REGIONAL REVIEW NOTIFICATION

ARC REVIEW CODE: R1909131

Name of Proposal: Reeves Creek (DRI 2996)Review Type: DRISubmitting Local Government: Henry CountyDate Opened: 9/13/2019Deadline for Comments: 9/30/2019

REEVES CREEK DRI 2996 Henry County ARC Natural Resources Group Review Comments

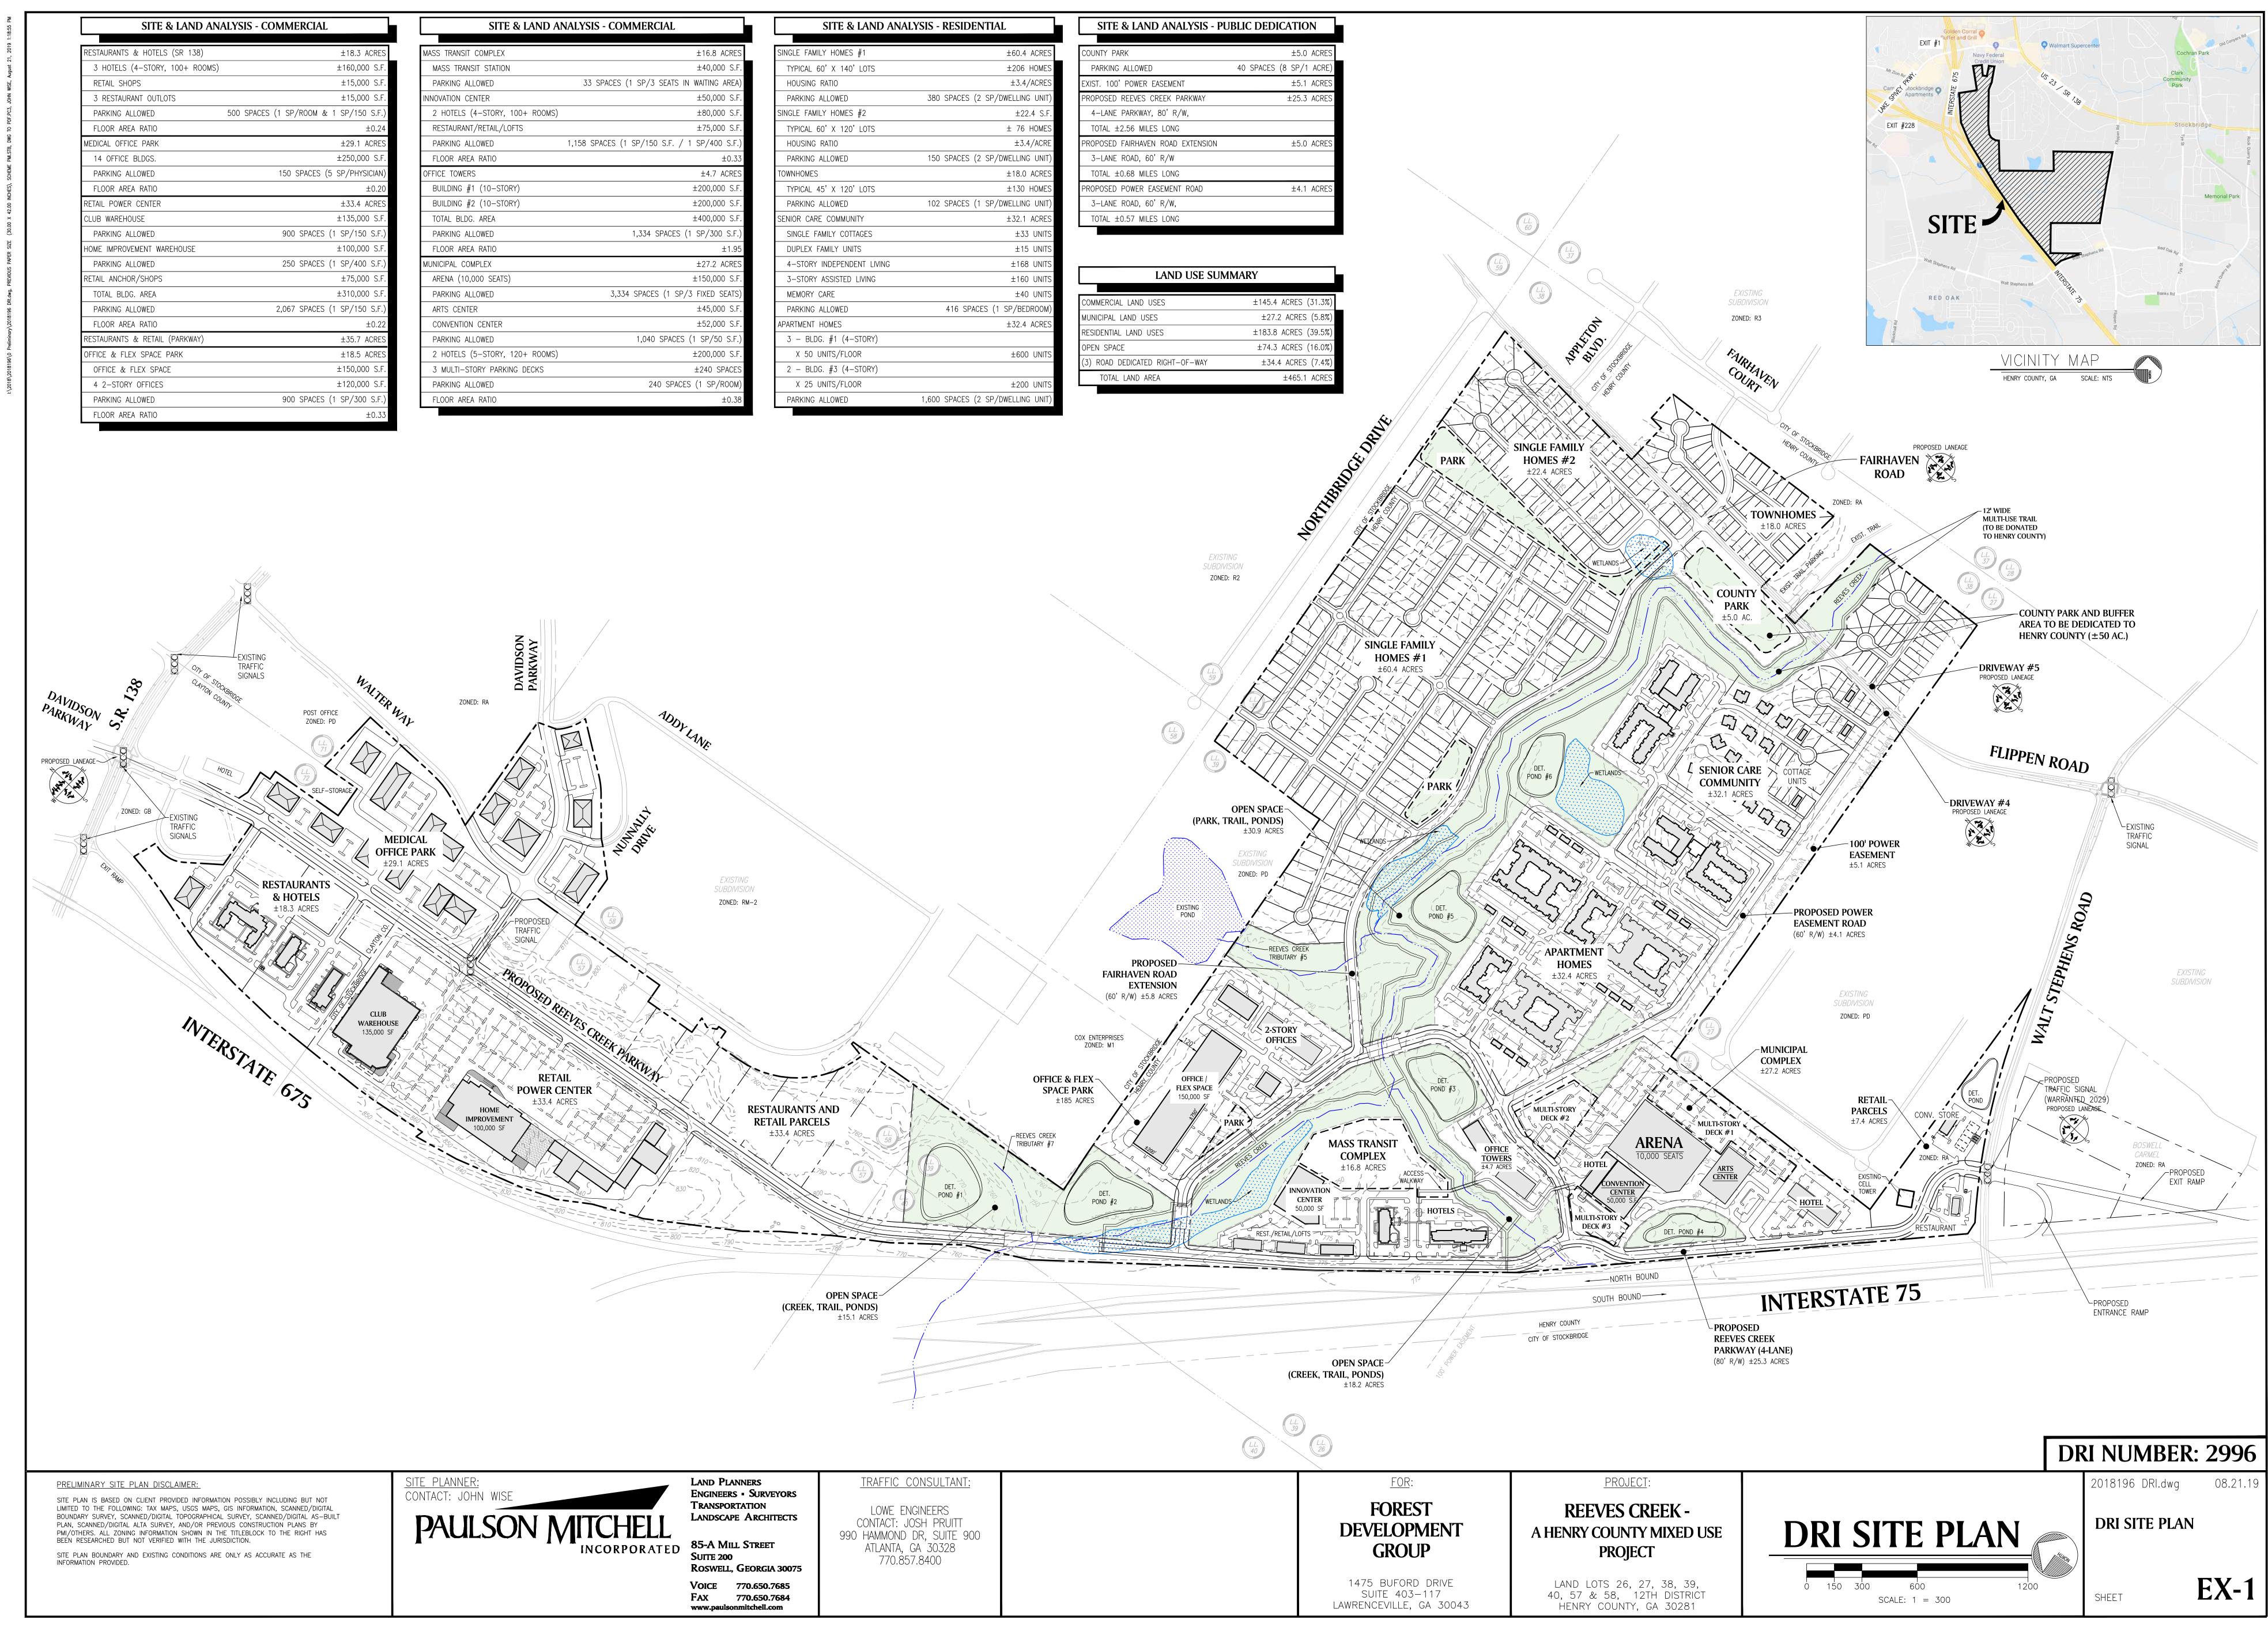
The site plan shows proposed local roads however details on whether pedestrian facilities are proposed are not provided on the site pan or in the analysis. Pedestrian facilities do not exist currently along roadways adjacent to the development.

The site plan shows proposed local roads however details on whether pedestrian facilities are proposed are not provided on the site pan or in the analysis. Pedestrian facilities do not exist currently along roadways adjacent to the development.

Trucks serving the commercial and warehouse uses will share local roads access points and driveways. The site plan does not designate separate entrance for vehicle and truck traffic. Residential uses are located so that vehicles for residential uses may avoid truck traffic.
